# UNITED STATES PATENT AND TRADEMARK OFFICE

APPLICATION NO.	FILING DATE	FIRST NAMED INVENTOR	ATTORNEY DOCKET NO.	CONFIRMATION NO.
10/698,961	10/31/2003	Sivakumar Ramasamy	0275M-000666/COB	8815

<b>Office Action Summary</b>	<b>Application No.</b> 10/698,961	<b>Applicant(s)</b> RAMASAMY ET AL.	
	<b>Examiner</b> Jeffrey Sharp	<b>Art Unit</b> 3677

### **DETAILED ACTION**

Figure 1 of WO 03/042554 A1

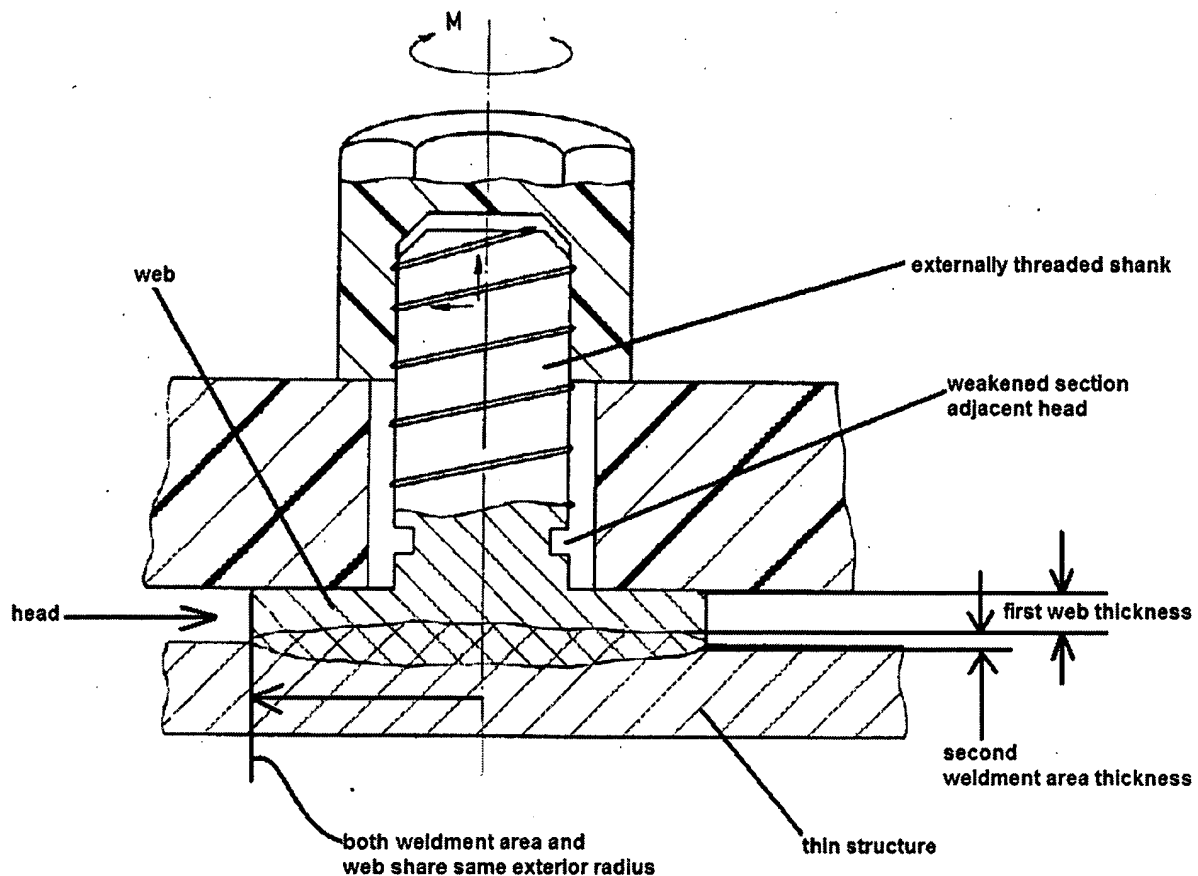
In short, and in its broadest reasonable interpretation, the WO 03/042554 A1 reference teaches a stud to structure construction/apparatus having a stud welded to a panel structure, said fastener having an externally threaded shank, a head with web portion having a first head thickness that is greater than a second weldment area thickness. The reference states that the shank has a first failure load less than a second failure load of the web. This would be clearly apparent and/or appreciated by those of ordinary skill in the art, because the web has a larger cross-sectional area than the shank. The weldment area taught by the WO 03/042554 A1 reference has a third failure load greater than said first failure load of the shank, since it, too, has a larger cross-sectional area than the shank. The shank possesses a weakened section positioned near the head. It is irrelevant whether or not the weldment area has a second head thickness that is less than 50% and preferably about 20-35% that of the thickness between a top and bottom surface of the head prior to welding, as this limitation is regarded as a product-by-process limitation and has not been given significant patentable weight. What is claimed is a welded construction/apparatus (post welding) and therefore, limitations directed to the structure of the fastener prior to welding are considered product-by-process limitations.

Figure 4 of Present Invention

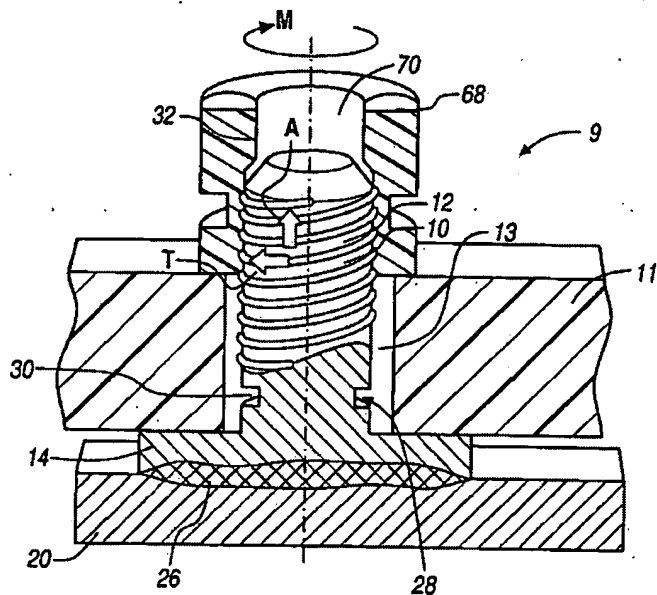
For the combination claims 8, 10-18, 31, 33, and 36-41, this argument is entirely not persuasive. Applicant is claiming a welded "stud to structure construction" and/or a "ring stud arc *welded* to a laminate panel". Figures 4 and 7 of the present invention show that after welding, the weldable fastener of the present invention will have different structural

characteristics than before it is welded. For example, the annular weldment area and flat welding surface no longer exists. The structural characteristics and performance characteristics of the present invention *after welding* are identical to that taught by WO 03/042554 A1. Therefore, the stud to structure connection and/or ring stud arc welded to a laminate panel claimed is not patentably distinct from the prior art in at least an obviousness sense. Accordingly, combination claims 8, 10-18, 31, 33, and 36-41 are still within an obvious scope of these references.

Moreover, it appears that the present invention has no significant performance improvement over the prior art WO 03/042554 A1 reference, as shown below. Absent further evidence from Applicant, the Examiner cannot see how the claimed invention "performs differently" *after welding*, even though the welding surface may differ *prior to welding*. Each and every first, second, third, and fourth failure load appears to be same when compared relative to each other as shown in the charts below.

Figure 1 of WO 03/042554 A1

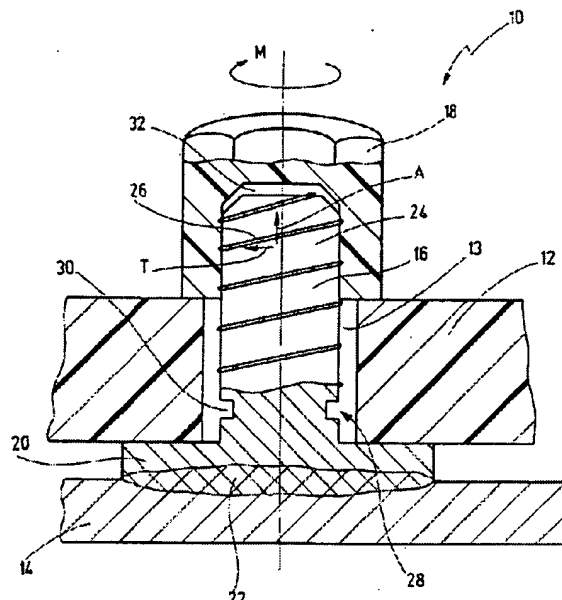
Examiner notes that WO 03/042554 expressly discloses a "gap" between a bottom surface of a web portion and a panel after welding, while maintaining the same relative failure loads between components.

Fig.4: (a)  $V(t)$  and  $I(t)$  plots obtained during resistance welding of two HSSA sheets (cycle time = 200 ms) and (b) micrograph of a polished section through such a weld.

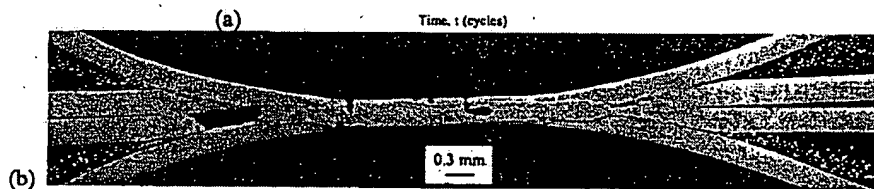
The device taught by WO 03/042554 A1 is useful in automotive applications, and particularly for use with auto body panels. Applicant submitted NPL suggests that metal/polymer laminates such as Hylite® are well-known in the automotive industry as advantageous equivalents to conventional sheet metal body panels, because they are lighter in weight, provide better insulation, and possess improved sound and vibration damping characteristics. Therefore, at the time of invention, it would have been obvious to one of ordinary skill in the art, to advantageously substitute a conventional automotive body panel with a laminate sheet metal structure for the abovementioned advantages. The functional limitations and interaction between the metal panels being fused together (particularly claim 18) is an inherent result of welding said metal laminate sheets as evidenced by the below illustration:
